# Access Compliance Report

## Public Rights-of-Way

### (Curb Ramps)

| Intersection ID: 3254 | Main Street: HARRINGHAM_LN | Cross Street: SPRING_PARK_DR | Location: NW           |

| ADA ID: 7DE3BB1054E0  | Ramp Type: Perp            | Initial Pass/Fail: Fail      | Overall Compliance: No |

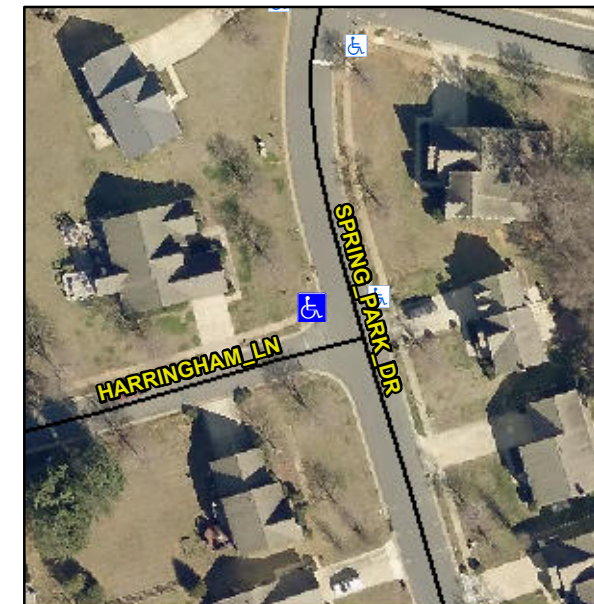
**Not Found, R304.5.1, R304.5.3**

| Compliance | Description           | Data | Compliance | Description                 | Data |
|------------|-----------------------|------|------------|-----------------------------|------|
| No         | Ramp Width (in)       | 35.0 | No         | Ramp XSlope (%)             | 5.5  |

**Remove & Replace Entire Ramp.**
